**RE: RESPONSES: Adequacy Review, Proposed Water Monitoring Plan, Leadville Mill,
Permit No. M-1990-057**

RE: RESPONSES: Leadville Mill, Permit No. M-1990-057, Conversion Application No. 3 (CN-3), Groundwater and Surface Water Specific Adequacy Review

LEADVILLE MILL

PERMIT M1990-057

Figure 1: Geology and Fracture Locations

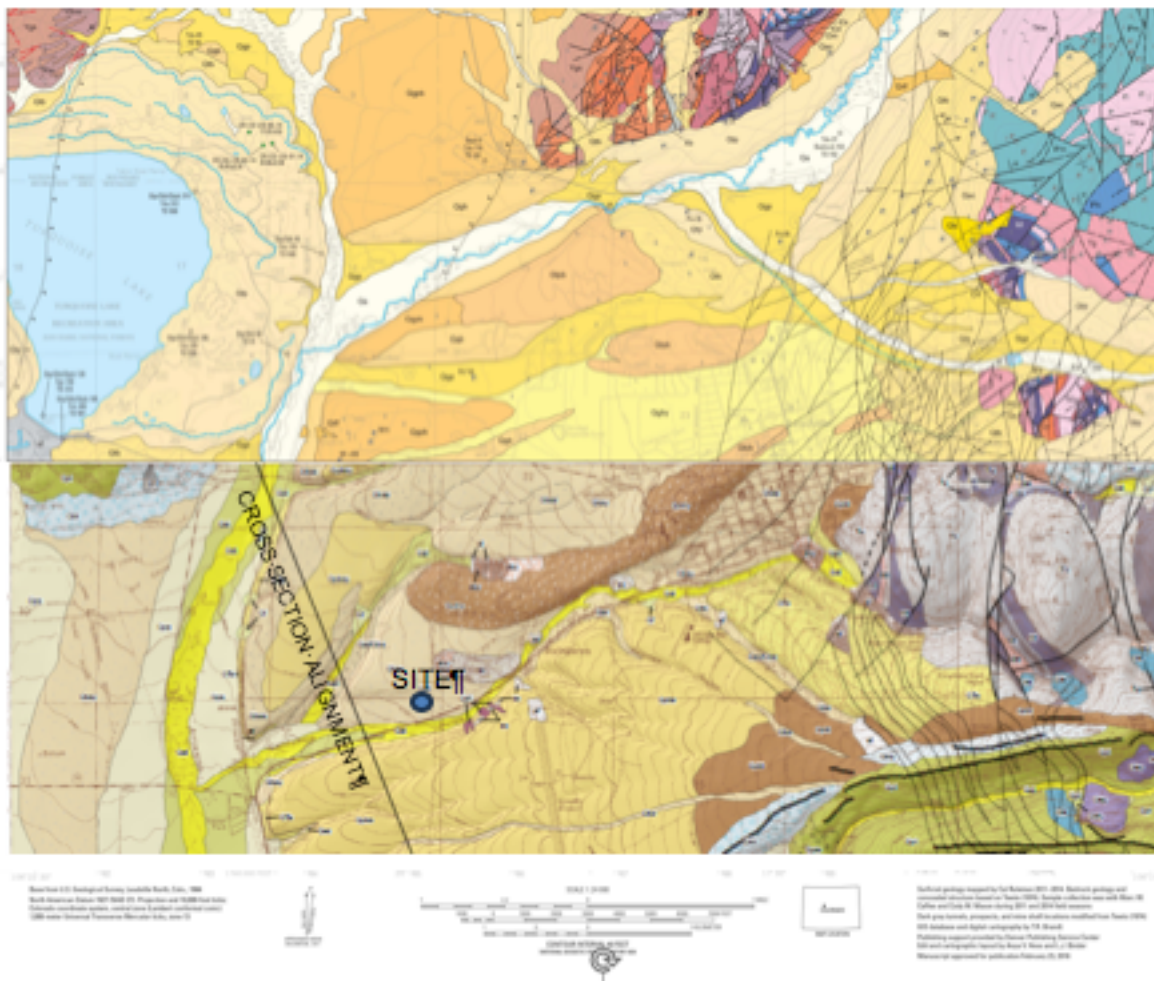
1. Pursuant to Rules 6.4.21(8)(b) and Rule 6.4.7(2)(b) please identify all known aquifers and related subsurface water-bearing fracture systems within two (2) miles of the affected lands. Description of the aquifer shall include characteristics such as transitivity, saturated thickness, stratigraphic units and other hydrologic characteristics.

3. Per Rule 6.2.21(8)(d) please identify and locate on a map all known major fracture systems that affect rock formations under the permit boundary that have the potential to be impacted by proposed processes at the site.

The site is underlain by an unconfined alluvial aquifer (**Figure 1**). The material beneath the site was mapped by (McCalpin et al., 2012, see reference in Figure 1 below) as Qboy: Bull Lake outwash deposits, younger, that are an "undivided brown, crudely stratified alluvium containing well-rounded to sub-rounded boulders, cobbles, pebbles, and sand." Detailed geologic logging of the monitoring-well borings advanced during the CERCLA Remedial Investigation activities was limited because they were advanced using air- and mud-rotary techniques.

Note: This map combines two maps. The northern map (C. Ruleman, T. Brandt, M. Caffee, B. Goehring, 2018, Geologic Map of the Leadville North 7.5' Quadrangle, Eagle and Lake Counties, Colorado, US Geological Survey Scientific Map 3400.) is a published product prepared by the U.S. Geological Survey. It was included to show the relationship of the bedrock fracturing to the site. The southern map, containing the site, is an Open-File report of mapping completed by the Colorado Geological Survey (J. McCalpin, J. Funk, D. Mendel, 2012, Leadville South Quadrangle Geologic Map, Lake County Colorado, Colorado Geological Survey Open-File Report 12-06)

Figure 2: Cross Section Showing Approximate Thickness of Alluvium

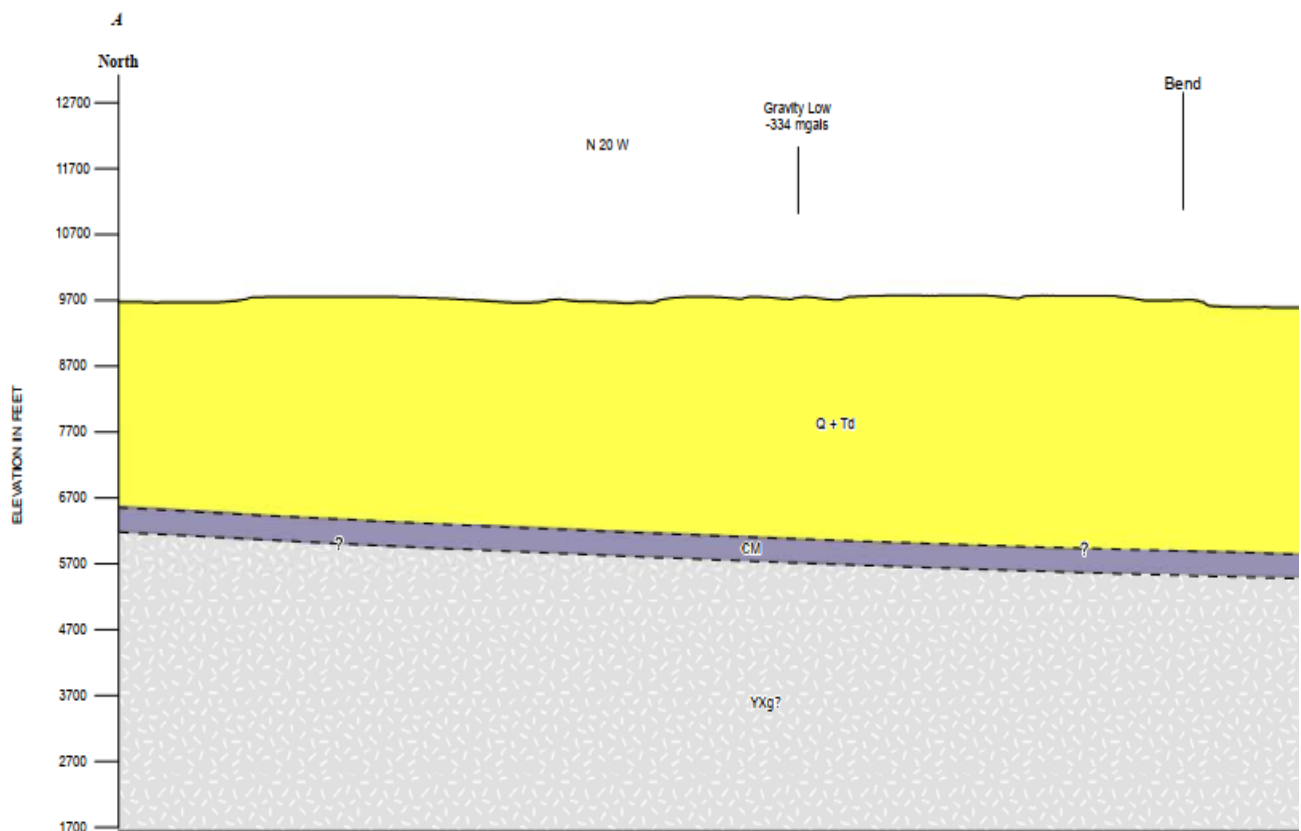
2. Per Rule 6.4.21(8)(c) please describe all geologic media down to and including the uppermost aquifer under the proposed permit boundary. Description should be detailed enough to identify any impermeable layers in alluvium.

The alluvial hydrogeologic unit relationship to fractures and estimated alluvium thickness is exhibited on **Figure 1** and **Figure 2**. **Figure 1** demonstrates that the nearest fracture is approximately 1.9 miles from the site, and it is inferred because it is buried beneath the alluvium. The cross-section shown in **Figure 2** shows that approximately 3,000 feet of alluvial materials separate the surface from the uppermost bedrock formation where fracturing, if it exists, would be present.

Figure 3: Groundwater Monitoring Wells and Potentiometric Contours

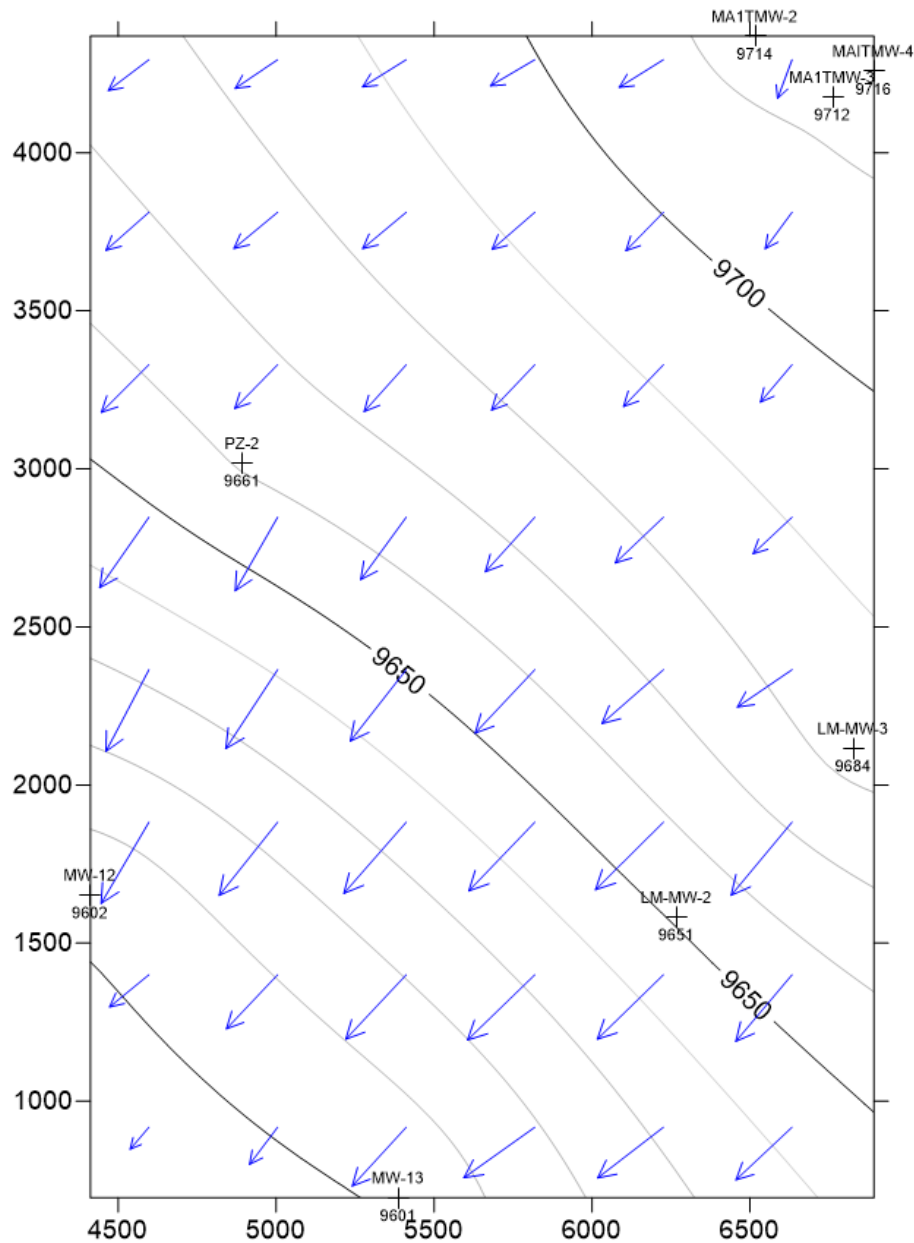
4. Per Rule 6.4.21(8)(e) please provide an in-depth description and illustration of the groundwater hydrology within a two mile radius of the permit. The description and illustration should include at a minimum a hydrologic model (e.g. ModFlow) that clearly shows how groundwater flows through and around the proposed permit boundary and a prediction of where contamination would go should there be loss of containment at the site. Additionally, it should include maps and cross sections that depict geologic strata and fracture systems. The model shall be able to demonstrate the proposed point-of-compliance well, LW-MW-3, is suitable and meets all the requirements under Rule 3.1.7(6).

A representative potentiometric surface map of alluvial wells immediately up-gradient, cross-gradient and down-gradient was generated to evaluate the hydrologic conditions surrounding the Leadville Mill. **Table 1** includes the water-level data used to generate the potentiometric surface shown in **Figure 3**.

The resulting groundwater gradient of 50-ft/1,620-ft, or 0.03-ft/ft, is sufficiently steep to negate concerns about substantial groundwater-flow deflections. Golder Associates (1996) estimated the alluvium hydraulic conductivity range in the Malta Tailings Area between 12 and 47 feet per day and the porosity between 0.10 and 0.35 (Golder, 1996, Table 3.1-1). The estimated advective groundwater velocity is estimated using the following parameters:

The resulting modeling effort is depicted on Figure C. Monitoring well LM-MW-2, the proposed compliance well, lies directly downstream from the site in an optimal position to intercept any operationally-caused releases.

Figure 4: Location of Wells Installed in California Gulch or the Arkansas River Alluvium Within 2-Miles of Leadville Mill

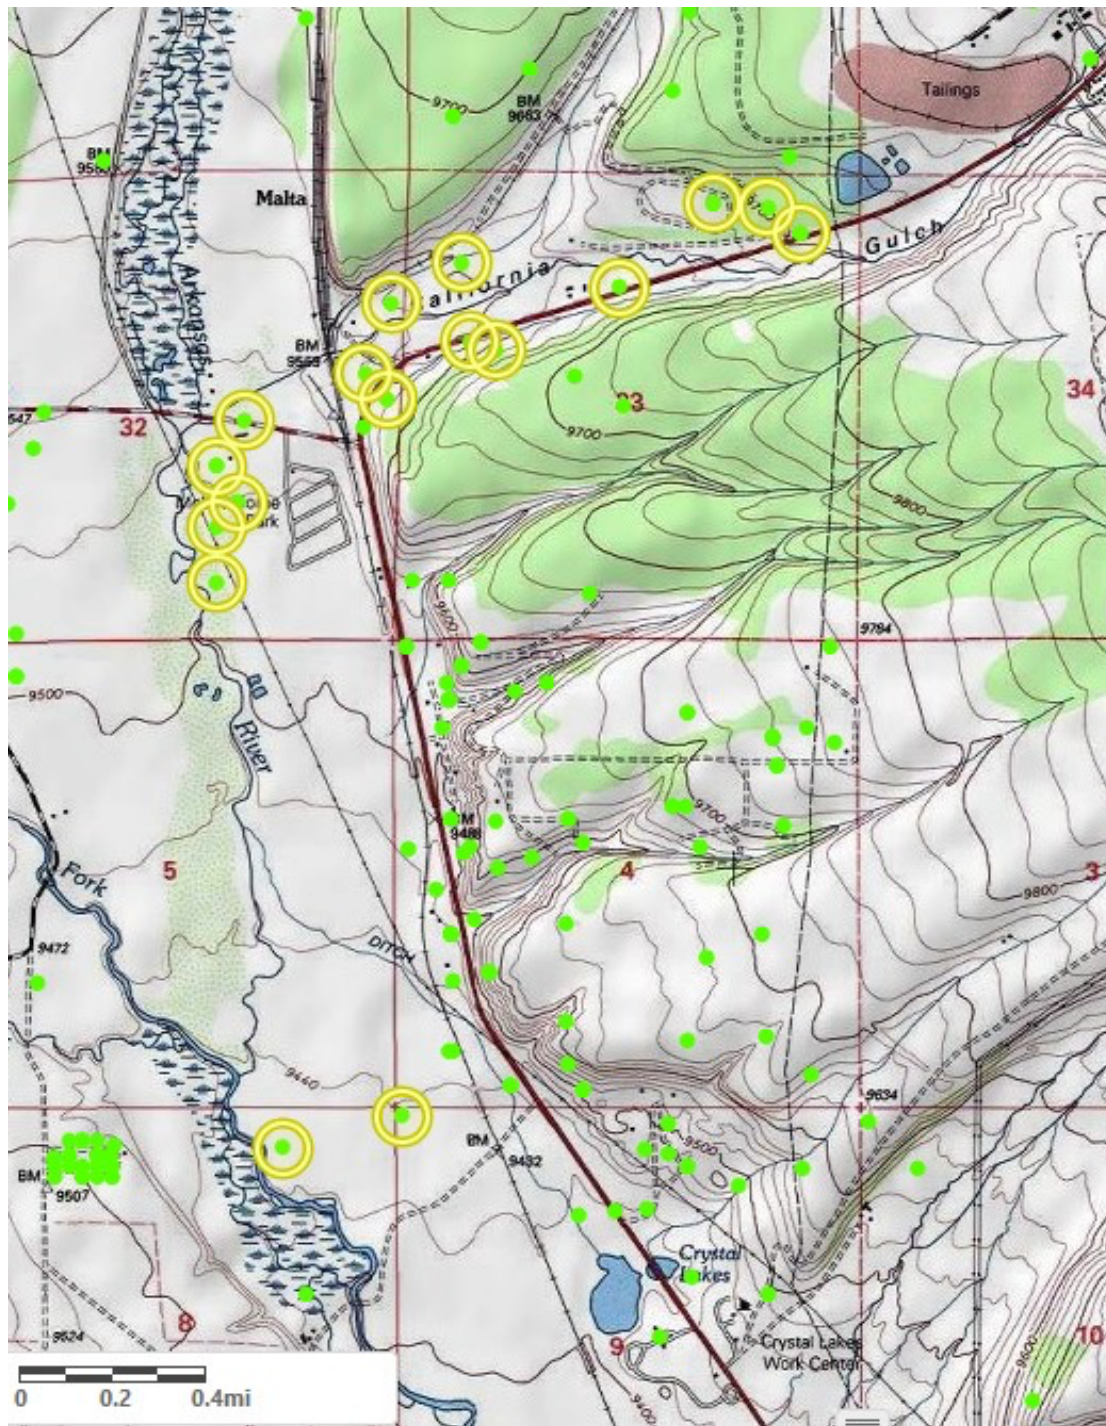
6. In Section 21.9.1 the Applicant states there are 510 domestic wells within a 2-mile radius and 11 wells are within 0.5 miles of the Mill. For all domestic groundwater wells downgradient of the site please provide a summary of construction information identifying which aquifer each well is utilizing. Please highlight the wells which are screened in the same first aquifer found immediately under the proposed permit boundary.

The selection of down-gradient wells is defined by the operational hydrogeologic conditions. Groundwater flowing beneath the site discharges into the California Gulch Alluvium and then into the Arkansas River alluvium, so the wells installed in these materials are included. The remaining wells are not in locations where they potentially tap this groundwater.

Figure 4 shows the 17 wells that meet these conditions within a 2-mile radius of the site, and their construction information is summarized in **Table 2**. All 17 of these wells tap alluvium.
